H. B. ROBINSON UNIT NO. 2  
LICENSE NO. DPR-23

REQUEST FOR LICENSE AMENDMENT - REVISION OF TECHNICAL SPECIFICATIONS

ATTACHMENT A

TECHNICAL SPECIFICATION MODIFICATIONS

Figure 3.10-3 Normalized Axial Dependence Factor  
for  $F_Q$  versus Elevation

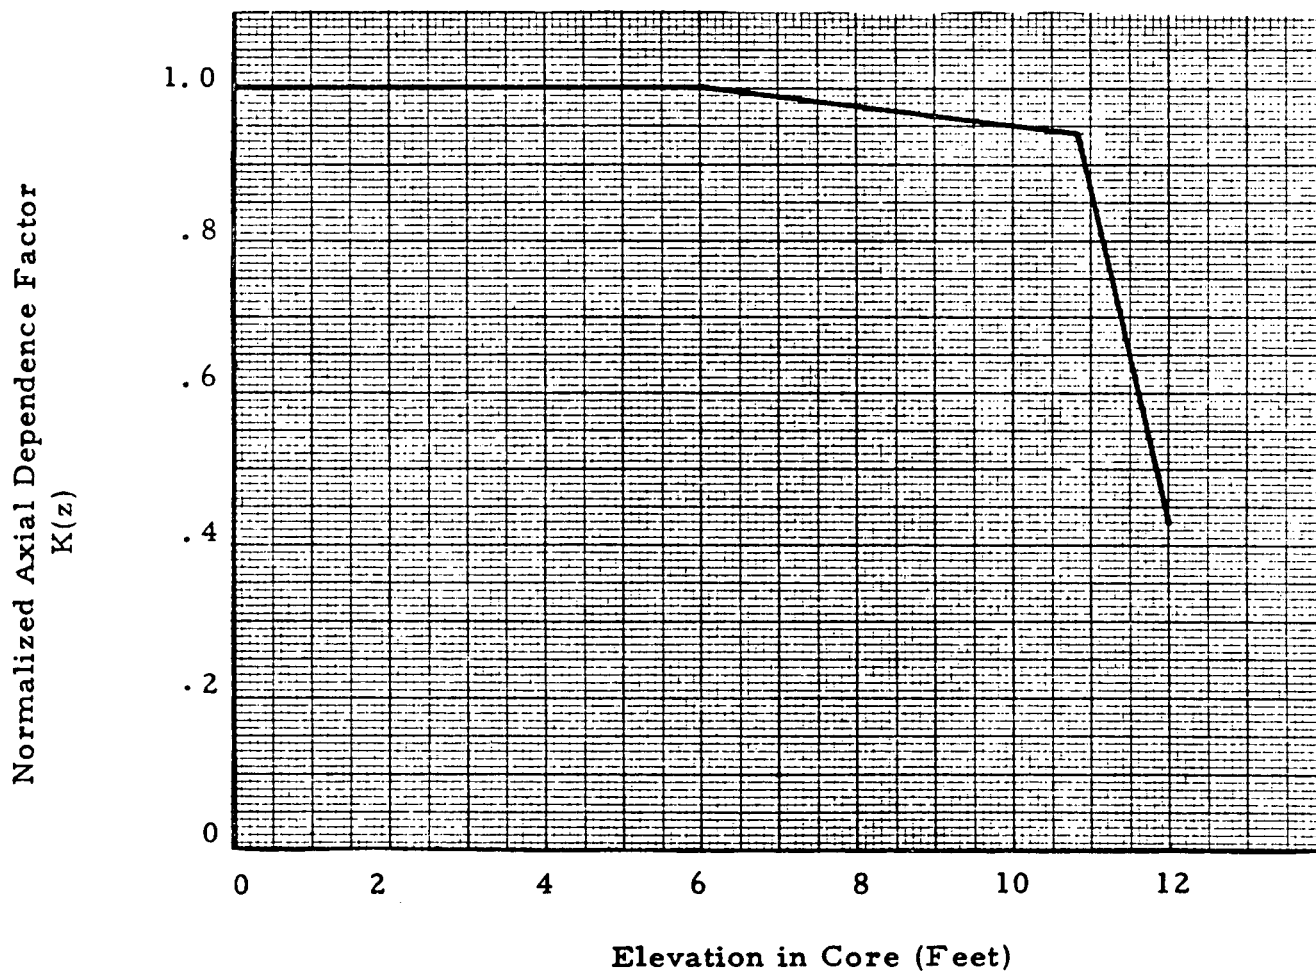
$$F_Q^N(z) = \frac{2.233 \cdot K(z)}{P} \text{ for } P > 0.5$$
$$= 4.466 \cdot K(z) \text{ for } P \leq 0.5$$

- a. P is the fraction of rated power at which the core is operating ( $P \leq 1.0$ ).
- b. K(z) is defined in Figure 3.10-3 and reflects the variation of limiting KW/ft as a function of core height above the core midplane.

$K(z)$  is the normalized peaking factor axial dependence used in the LOCA analysis and is shown in Figure 3.10-3. For normal operation, it is not necessary to measure these quantities. Instead, it has been determined that, provided certain conditions are observed, the above hot channel factor limits will be met; these conditions are as follows:
